MODERNIZATION AT CURRAN MIDDLE SCHOOL FOR:

MARK	DATE	DESCRIPTION
SD		
CD		
01	08/23/07	ADDENDUM 1
02	09/11/07	ADDENDUM 2
03	11/01/07	ADDENDUM 3

SHEET TITLE
INTERIOR ELEVATIONS BUILDING E

SHEET IDENTIFICATION NUMBER
A-238
SHEET 27 OF 46

B3 MECHANICAL E-118
1/4"=1'-0"

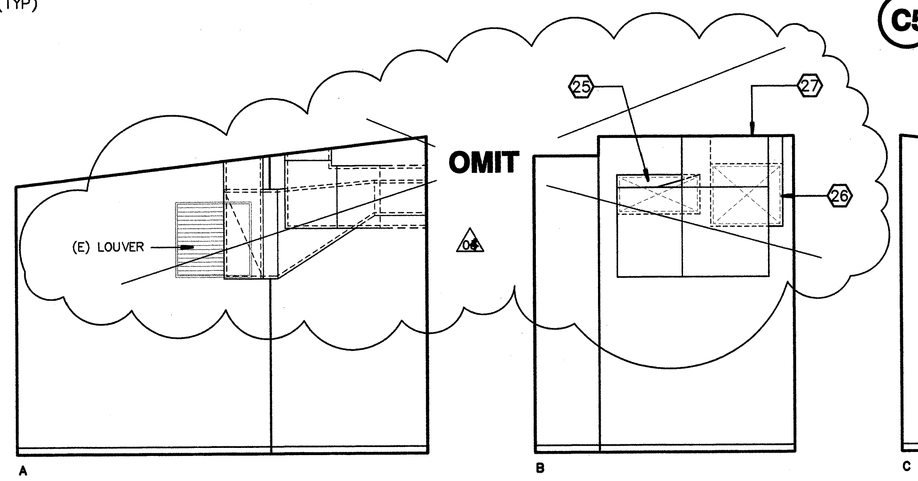
Item No. 16: Refer to Sheet A-238
Interior Elevation "B3" Elevation "A" & "B" omit all references to HVAC related work only. Revise Keynote #4 to read. "Existing cabinet to remain, remove and replace all doors, drawer fronts, & face plates. Finish per specifications." Delete Keynotes #'s 2,3,25, 26, & 27.
